CONSERVATION TEAM CONSULTATION APPLICATION RESPONSE

APPLICATION REF:	25/02330/FP & 25/02331/LBC
CASE OFFICER:	AHD
APPLICATION SITE:	1 John Street, Royston, Hertfordshire SG8 9BE
DESCRIPTION OF WORKS:	Change of use of existing offices into 6 bed HMO (Class C4). Internal alterations to facilitate change of use of existing offices into 6 bed HMO (Class C4).

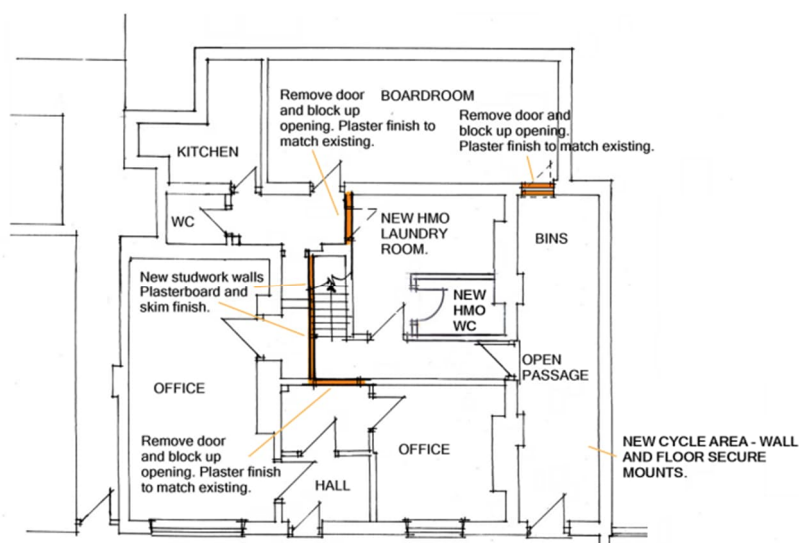
The WC serving the HMO would impact upon the proportions of the central room and which also includes a fire surround which is in the style of the most common Regency

fireplace pattern with reeded jambs and corner roundels. Whilst I cannot say whether this is original or reproduction it is very much in keeping with the building's early C19 date and similar fire surrounds exist elsewhere in the building.

I would like to understand what is required to service the laundry room, for instance the WC will require plumbing. Although the 'middle room' is currently used as a store, it is a 'higher value' interior when compared with the boardroom which is in a later flat roof addition. In my view, a better arrangement may be to:

- Allocate half of the boardroom to providing a laundry and WC to the HMO albeit this would only be accessible from the open passage and not from the access corridor
- Close off the existing door to the storeroom (currently shown as proposed access to laundry room) and maintain other door access to the 'middle room' for use as a third office. The half of the boardroom that remains with the office scheme could then be utilised as a store. This will keep the middle room in tact with no plumbing etc.

If this is not agreed then an alternative but less favourable fall back position would be to reposition the WC to the diagonally opposite corner of the room which would also be in front of what would be a newly formed section of stud infill where the door is currently shown closed off. I positively encourage my suggestion above.
